[Docket No. FAA-2020-0442; Project Identifier AD-2020-00260-E; Amendment 39-21640; AD 2021-14-13]

Airworthiness Directives; Pratt & Whitney Turbofan Engines

ACTION: Final rule.

Figure 1 to Paragraph (g)(1)(iii) – Crack Inspection Critical Areas

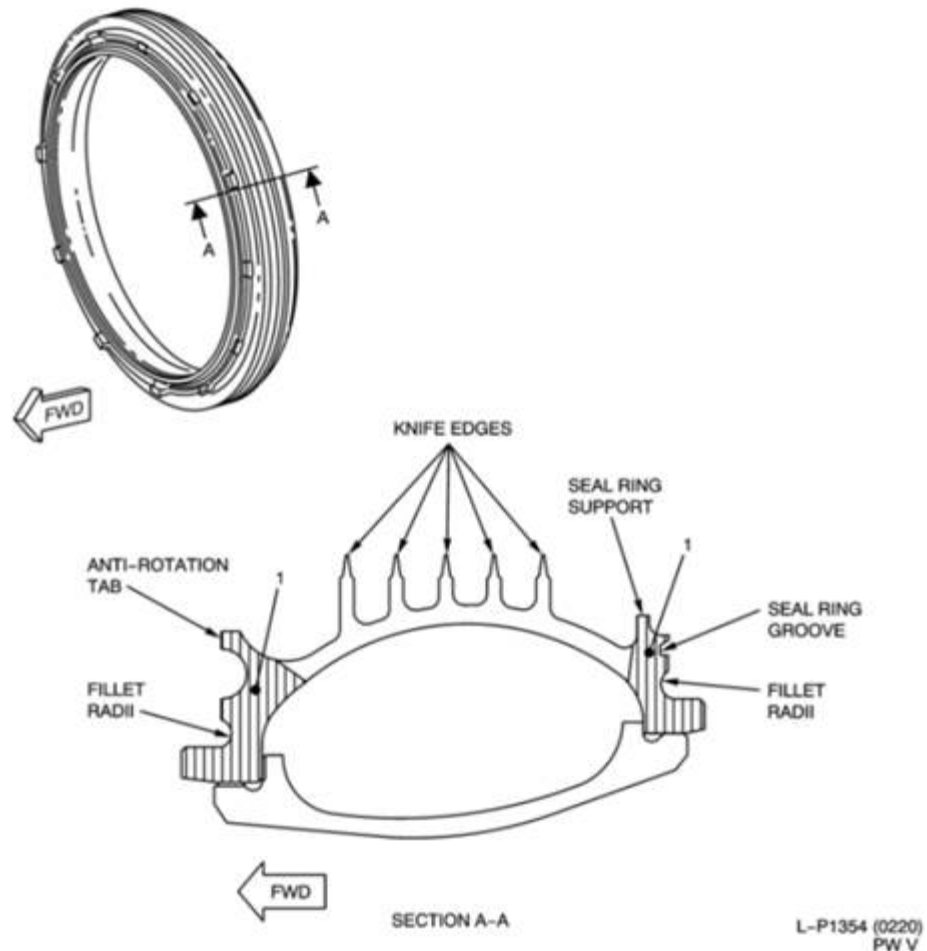
Delta commented that individual part serviceability should not depend on the inspection results of other parts. Delta also commented that if inspections are not possible which would allow the mating HPT 1st-stage disk or the HPT 2nd-stage hub to be deemed serviceable, independent from inspection status of the HPT 2nd-stage air seal assembly, then the manufacturer should revise the engine manuals to clarify that the mating HPT 1st-stage disk or HPT 2nd-stage hub cannot be made serviceable unless an inspection of the HPT 2nd-stage air seal assembly indicates it is free of cracks. Delta stated that this would remove the possibility that the mating HPT 1st-stage disk or HPT 2nd-stage hub would be made serviceable and then installed in an engine before the HPT 2nd-stage air seal assembly is inspected.

MTU requested clarification regarding whether the mating HPT 1st-stage disk or HPT 2nd-stage hub needs to be replaced if a crack is found after performing the inspections proposed by paragraph (g)(2)(iii) of the NPRM (paragraph (g)(1)(iii) of this AD), or if both the mating HPT 1st-stage disk and HPT 2nd-stage hub need to be replaced.

Delta and MTU requested that the FAA clarify the location of the forward and aft edges of the HPT 2nd-stage air seal assembly. Delta asked if the forward edge is the barrel section forward of the #1 knife-edge or any part that extends beyond the barrel section.

Delta and FedEx requested that the FAA clarify the definition of “through-crack.” Delta asked if a “through-crack” is a crack going through the axial direction or radial direction of the HPT 2nd-stage air seal assembly. Delta referenced Figure 5 of NDIP-1217 that appears to show a through-crack in the axial direction. Delta inferred from paragraph (i)(4) of the NPRM that a through-crack is in the radial direction. Delta requested a diagram to help illustrate what constitutes a through-crack.

FedEx stated that a lenticular seal is a two-piece component that becomes an inseparable assembly during manufacturing. As a result, it would be impossible to distinguish a through-crack from a surface crack over a large area of the HPT 2nd-stage air seal assembly’s exterior since its interior surfaces are inaccessible. FedEx cited Chapter 72-52-60, Inspection/Check-01, Figures 801 and 801A, of the PW2000 Series Engine Manual, which highlights areas where through-thickness cracks are critical. According to FedEx, however, these images fail to address the ability to determine whether a surface crack is a “through-crack.” Additionally, the PW2000 Series Engine Manual does not provide dimensions that bound the areas making HPT disk replacement subjective.

The FAA did not revise this AD in response to this comment. A crack, as identified in the shaded regions of Figure 1 to paragraph (g)(1)(iii) of this AD (Figure 1), which extends towards the knife-edge region of the HPT 2nd-stage air seal assembly, impacts the serviceability of the mating HPT 1st-stage disk and the HPT 2nd-stage hub. A crack identified in the shaded region of Figure 1 of this AD of the HPT 2nd-stage air seal assembly results in the requirement to remove the HPT 2nd-stage air seal assembly, mating HPT 1st-stage disk, and HPT 2nd-stage hub.

If a crack is found as identified in the shaded region of Figure 1 to paragraph (g)(1)(iii) of this AD (Figure 1) that extends toward the knife-edge region of the HPT 2nd-stage air seal assembly, this AD requires replacement of the HPT 2nd-stage air seal assembly, mating HPT 1st-stage disk, and HPT 2nd-stage hub.

The FAA removed references to “forward edge” and “aft edge” of the HPT 2nd-stage air seal assembly from this AD. In their place, the FAA added Figure 1 to paragraph

(g)(1)(iii) of this AD to specify the locations of the HPT 2nd-stage air seal assembly that require inspection for cracks.

The FAA agrees that it is difficult to differentiate between a surface crack and through-crack; therefore, the FAA removed references to “through-crack” from this AD. The FAA notes that any crack, in any direction, found in the HPT 2nd-stage air seal assembly, requires removal of the HPT 2nd-stage air seal assembly from service. As stated in an earlier response, the FAA added Figure 1 to show the locations of the HPT 2nd-stage air seal assembly that require inspection for cracks. However, the FAA is not providing dimensions that bind the areas. If the inspections of the HPT 2nd-stage air seal assembly reveal a crack in the shaded regions of Figure 1, which extends towards the knife-edge region, the HPT 2nd-stage air seal assembly must be removed from service.
